LARAMIE COUNTY PLANNING & DEVELOPMENT DEPARTMENT

MEMORANDUM

TITLE: Review and Final Action on a Site Plan for the Bit-O-Wyo Ranch and Events, located in a portion of land situated in the NE ¼ of Section 11, Township 14 North, Range 70 West, of the 6th P.M., Laramie County, WY.

Bit-O-Wyo Ranch and Events Commercial Site Plan / Class C Conditional Use Permit

1 Bit-O-Wyo
CONCEPTUAL SITE PLAN

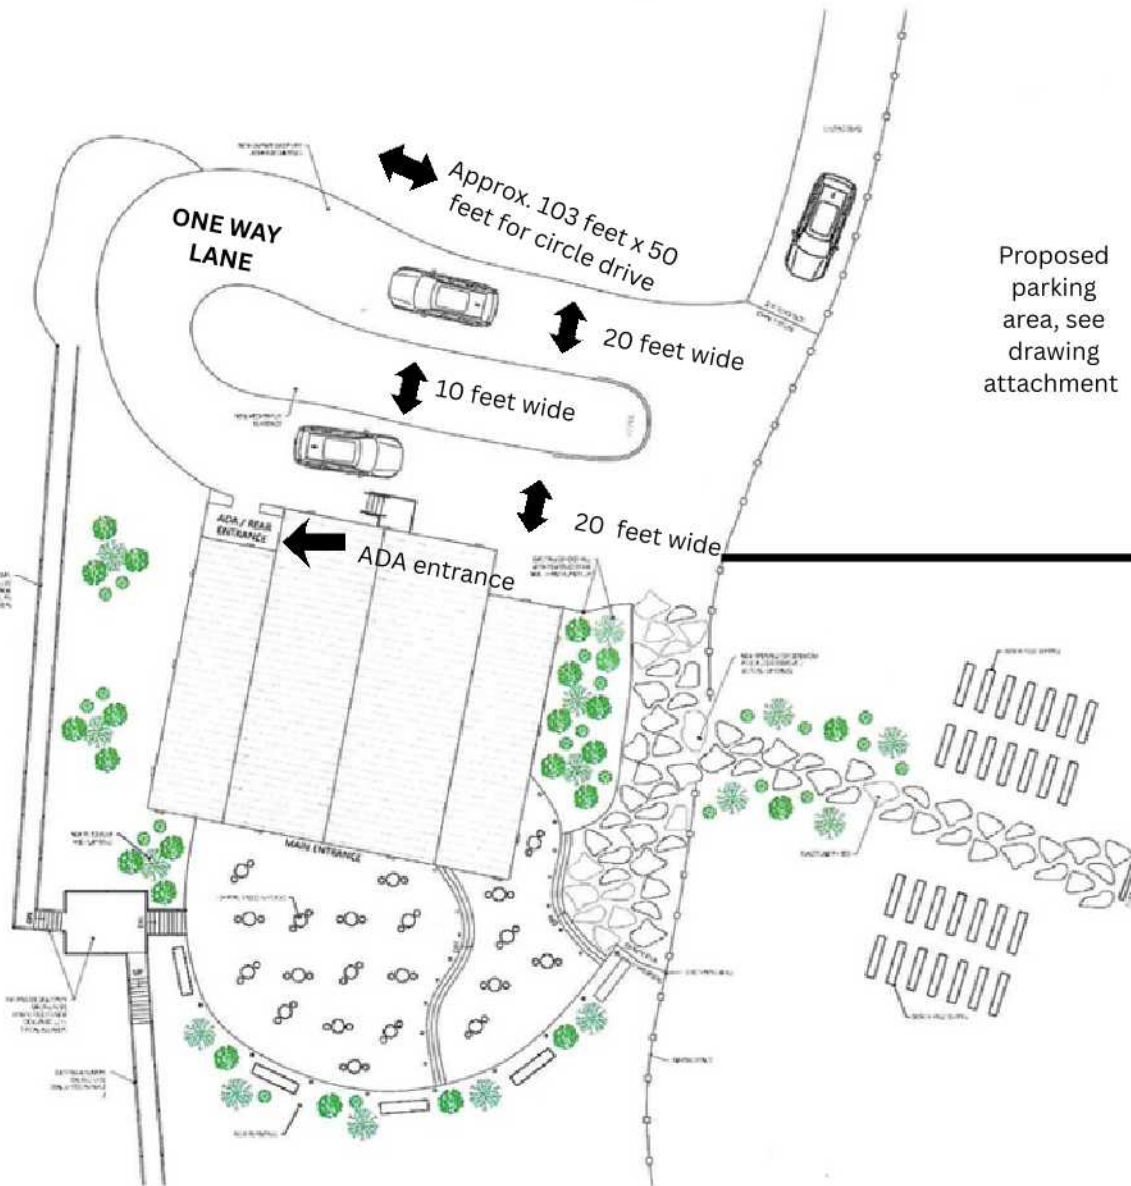
6. 07/10/2026 Workflow BUILDING FIRE CODE REVIEW GENERAL
JEFFREY.COOPER@LARAMIECOUNTYWY.GOV
Fire Apparatus Roads required per 2024 IFC section 503
20' minimum lane width shall be maintained with turning
radius determined by LCFA for the type of vehicle most likely
to respond. Current site plan shows no areas for fire
apparatus turn around and must be included on site plan.

2. The radii on the access roadway/lane needs to be called out. May need to provide/show turning movements for emergency vehicles to show they can make it around/through the one way lane if the radii are too small.

4. The parking layout drawing indicates the parking area is to be 227 feet long with 25 spaces that are 9.5 feet wide. 25 spaces at 9.5 feet wide would be 237.5 feet long at least and that would be just for perpendicular parking, it would end up being longer for angled parking.

6. How will the parking spaces be delineated? With concrete parking blocks or what method will be used? This needs to be indicated on the site/parking plan drawings.

**Applicant Response: Emergency vehicle turnaround is at the north end of the property.
Site plan to be adjusted to reflect a 20 foot road width for proper emergency turnaround.**

Applicant Response: We will adjust, if needed. We have a 75 foot width allotment on our BLM ROW. Will refer to Matt Butler for which emergency vehicles could be used.

Applicant Response: Parking will be perpendicular and we will adjust the site plan to show 237.5 feet.

Applicant Response: BLM requires temporary signage on the ROW for parking. We will use temporary traffic cones, drums and tubular markers to delineate parking spaces.
